## CHANGE TO INFRASTRUCTURE AGREEMENT

Town Planning Report - Request for Change to *Pelican Waters Southern  
Lake Infrastructure Agreement 2011*

**Pelican Waters Heart Pty Ltd**

**September 2019**

**Figure 8 – Alternative Drawing 5 (Bicycle and Pedestrian Infrastructure Network Sequencing).**

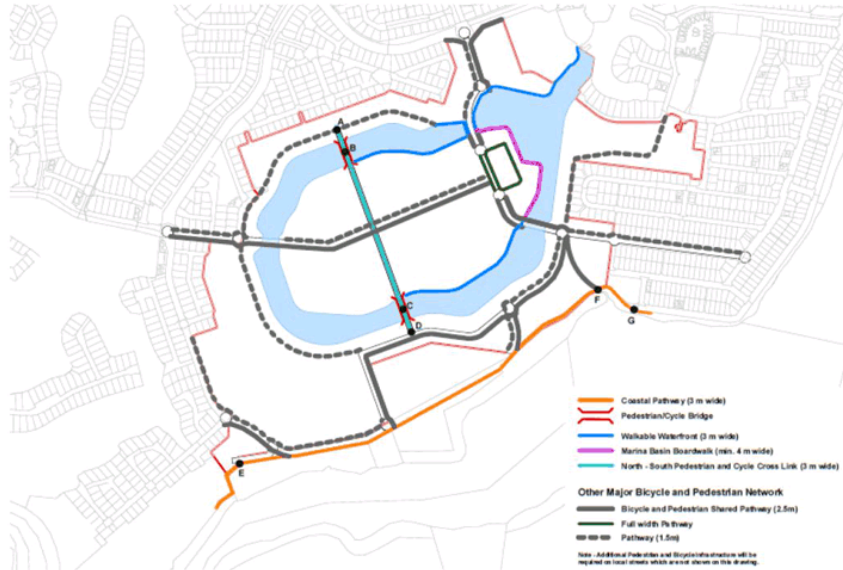
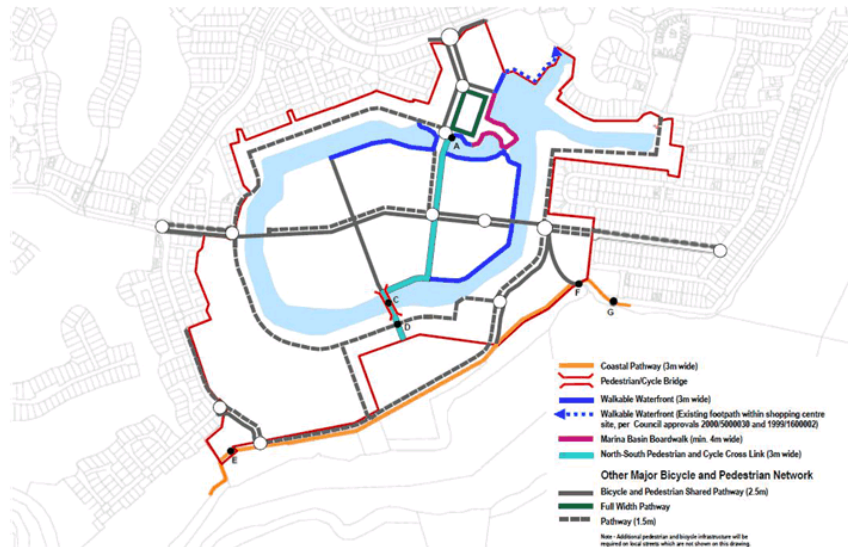
3.2.2 **Figures 7 and 8** below show the current and proposed alternative versions of the *Infrastructure Agreement's* Drawing 5 (*Bicycle and Pedestrian Infrastructure Network Sequencing*). **Figure 8** accommodates the revised town centre core location and a rationalised and improved bicycle and pedestrian circulation network which facilitate removal of the northern pedestrian/cycle bridge.

*Work Contribution for bicycle and pedestrian infrastructure from Point A to Point D and bridges at Point ~~B~~ and C as indicatively identified on Drawing 5.*

*(b) bicycle and pedestrian bridges across the waterway at ~~Point B~~ and Point C, as indicatively identified on Drawing 6.*

Figure 10 – Proposed Alternative Drawing 7  
 (Urban Open Space and District Community Facilities Infrastructure Network Sequencing).

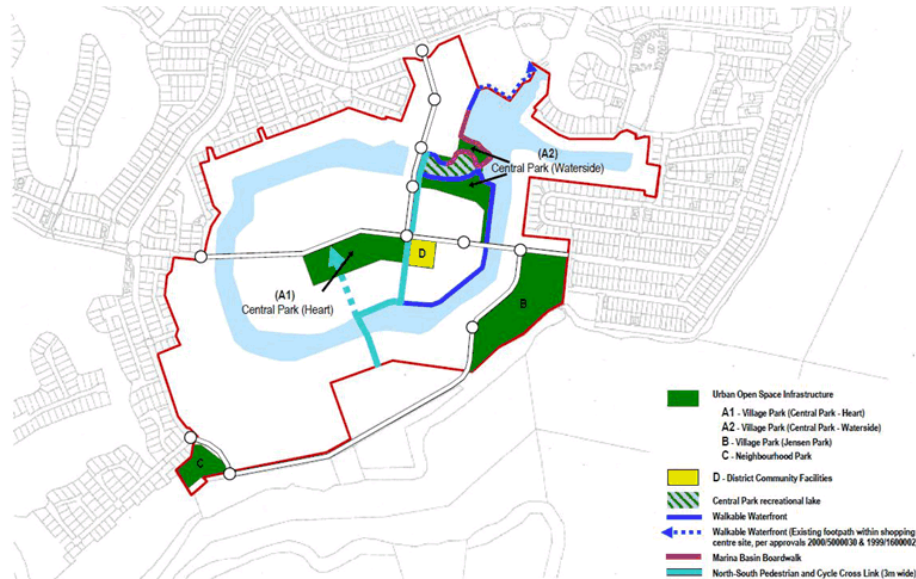
3.2.3 Figures 9 and 10 below show the current (3ha) and proposed alternative Village Park (Central Park) configuration, with central (2.0ha) and waterfront (1.428ha) components integrated (along the amended North-South Pedestrian and Cycle Cross Link) with the waterfront, district community facilities, park link and mixed use precinct, the Central Park recreational lake and the relocated town centre core.

*Land Contribution and Work Contribution for urban open space infrastructure being a Village Park at points ~~A1~~ and ~~A2~~ as indicatively identified on Drawing 7.*

*(a) a minimum of 3 hectares of land **in total** for a Village Park at Points ~~A1~~ and ~~A2~~ as indicatively indicated on Drawing 7;*

**Figure 11 – Drawing 3 (Pelican Waters Southern Lake Transport Infrastructure Network Sequencing).**

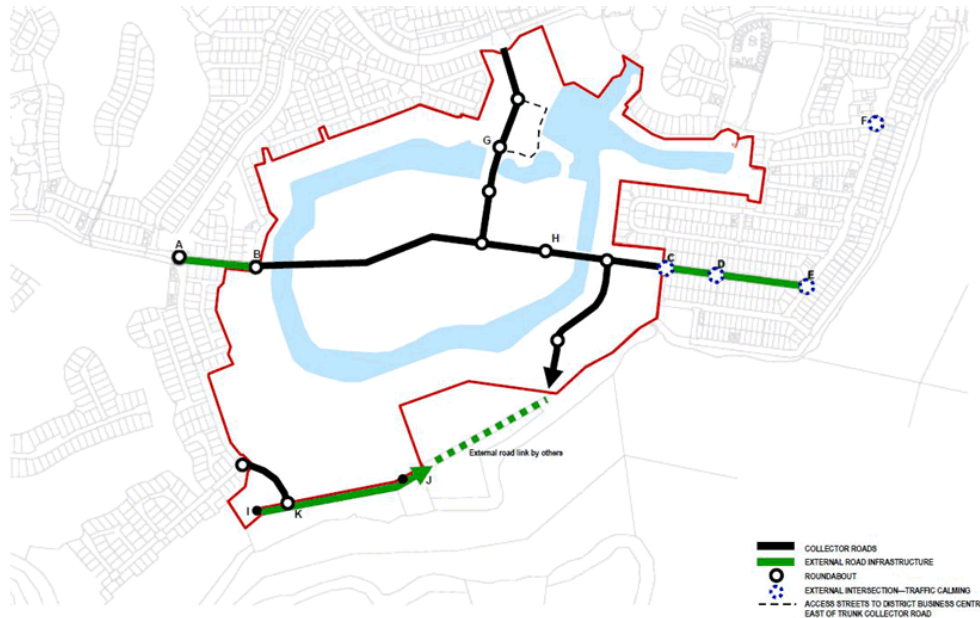
Drawing 3 of the *Infrastructure Agreement* identifies external roadworks Points C-F, as shown on **Figure 11** below.

3.3.3 It can thus be interpreted that Condition 15 of the Stage 4B-I approval, when read in conjunction with the April 12 GIA endorsement, establishes external intersection configurations and works requirements that Council considers to be generally in accordance with the requirements of the *Infrastructure Agreement*. The developer is agreeable to implementing these changes, and to this end the draft

variation deed (refer **Appendix A**) incorporates the required changes to the *Infrastructure Agreement* Schedule 2 items 3.1.6. and 3.1.7. Further information in this regard is provided in Section 7 herein.
